Re: Ivanpah Solar Electric Generating System, Docket No. 07-AFC- 5

Docket No. 07-AFC-5

INTERVENOR SIERRA CLUB' S SUPPLEMENTAL TESTIMONY

SUPPLEMENTAL TESTIMONY OF SCOTT CASHEN

Figure 1 depicts a project reconfiguration that would reduce impacts on desert tortoise. The southern boundary of the proposed alternative coincides with sampling locations determined by the applicant to have plant species richness too low for desert tortoise translocation (i.e., occupation).

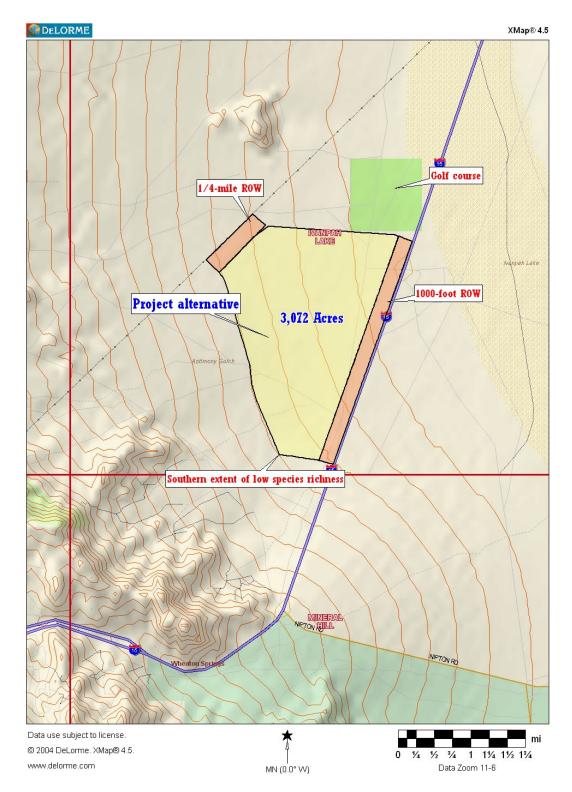
Figure 1 depicts a reconfiguration of the Project such that it would reduce impacts on desert tortoises and desert tortoise habitat. The proposed alternative encompasses land that contains approximately one-half the density of desert tortoises as the proposed Project site. Furthermore, it encompasses land known to provide lower value to the organism due to its proximity to I-15, the golf course, and other types of anthropogenic disturbance. These considerations are particularly important to the long-term recovery of the species. "High quality" habitat provides little value to recovery if it is not suitable for long-term occupation. As desert tortoise expert Dr. Ron Marlow stated in his testimony, "lots of really good potential habitat is not occupied by tortoises because of the impacts of the existing road."⁹ The proposed alternative site encompasses such habitat.

The proposed alternative excludes the 1000-foot Caltrans ROW for the Joint Point of Entry and a 0.25-mile ROW for the Los Angeles Department of Water and Power. It encompasses approximately 3,072 acres of land adjacent to anthropogenic disturbance and known to have low plant species richness. Overall, the proposed location occupies the lower elevation region that has lower species diversity.¹⁰ ¹¹ From an ecological perspective, the proposed alternative would aggregate anthropogenic disturbance, and thus reduce the many indirect Project impacts (e.g., fragmentation, invasive species, edge-effects) on the desert tortoise.
